**SUBJECT:** NuScale Power, LLC Response to NRC Request for Additional Information No. 164 (eRAI No. 8935) on the NuScale Design Certification Application

NuScale Response to NRC Request for Additional Information eRAI No. 8935

**eRAI No.:** 8935

**NRC Question No.:** 03.07.02-23

**Figure 3.7.2-149: Non-Vertically Propagating Seismic Wave RXB Sensitivity Analysis Cases**

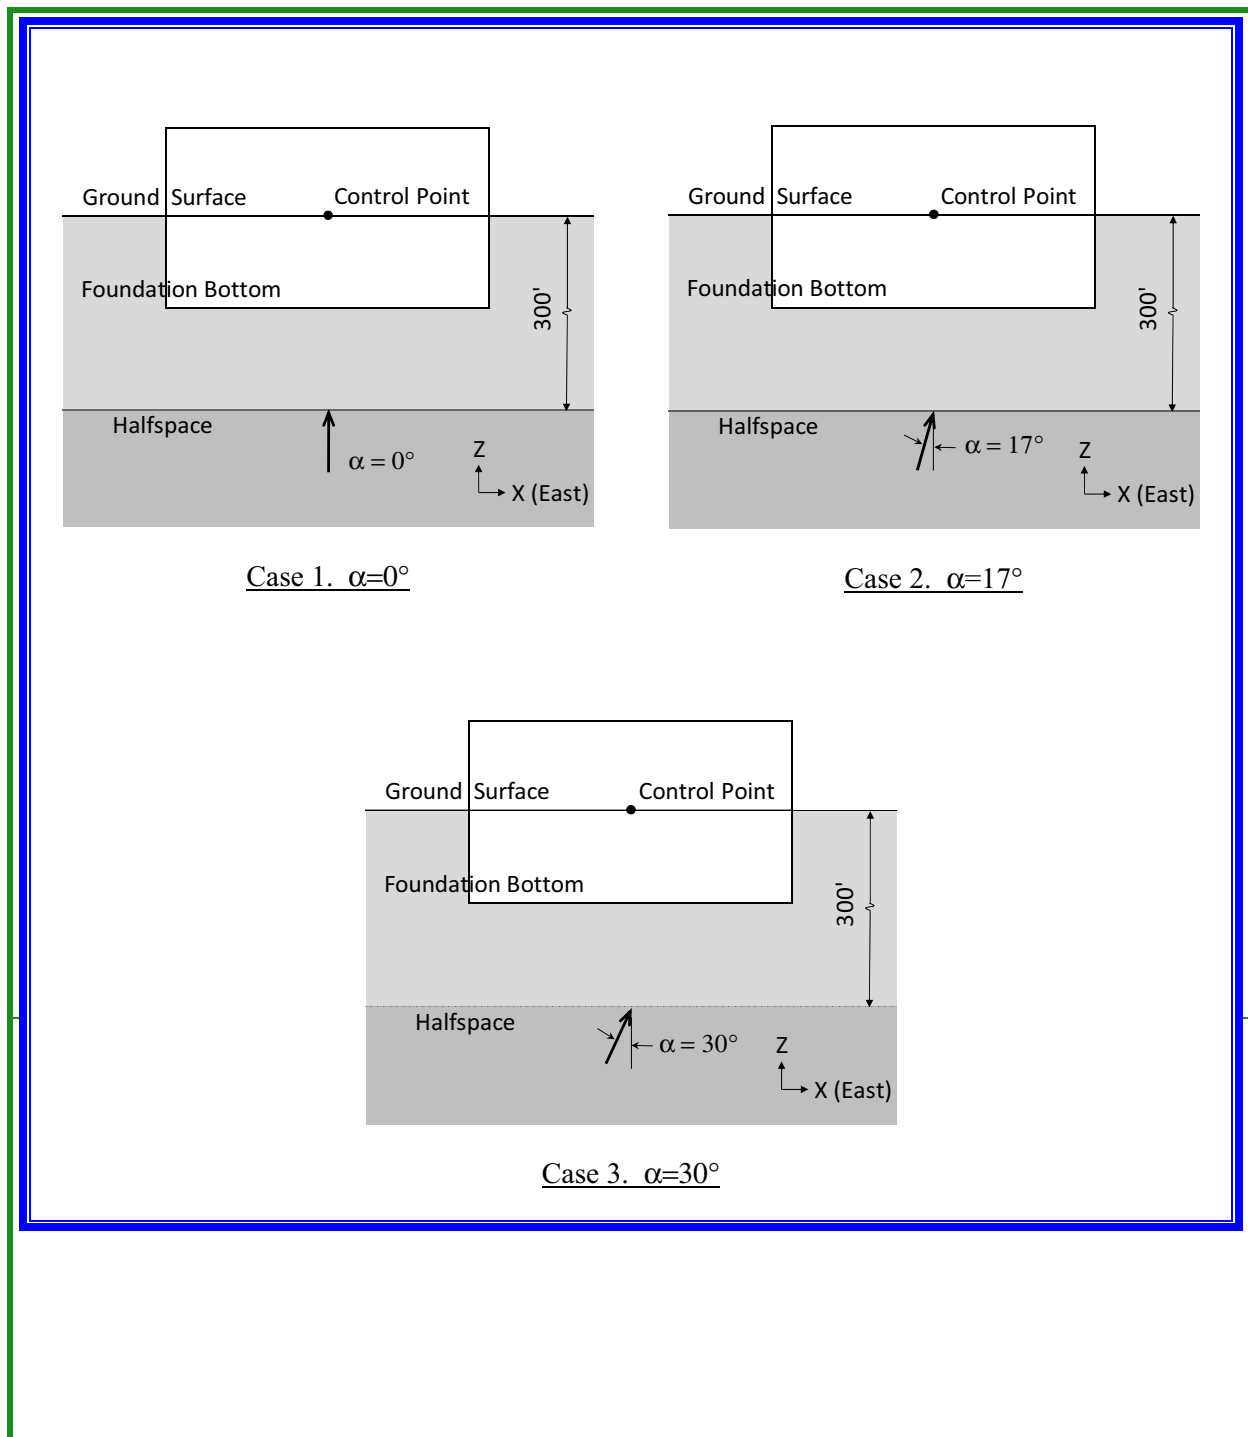
DSRS Section 3.7.2 provides guidance that, for soil-structure interaction (SSI) analysis for deeply embedded structures, proper consideration should be given to uncertainties associated with kinematic interaction, non-vertically propagating shear waves, sidewall impedance calculation, and other effects such as the development of gaps between the soil and structure specifically for strong-motion earthquakes. For non-vertically propagating shear waves, a sensitivity evaluation can be performed to determine whether this is an important effect to be included in the SSI analysis. Staff has not been able to identify how the applicant has considered these uncertainties associated with SSI of deeply embedded structures in the seismic analysis of NuScale Category I SSCs. Provide an explanation for what analyses the applicant has performed and how these uncertainties have been considered.

FSAR Tier 2, Section 3.7.2.1.1.3 and FSAR Tier 2, Figures 3.7.2-149 through 3.7.2-155 have been revised as described in the response above and as shown in the markup provided in this response.

Analyses were performed and results compared for the following angles of incidence,  $\alpha$ , where  $\alpha$  is measured from the vertical axis (see Figure 3.7.2-149):
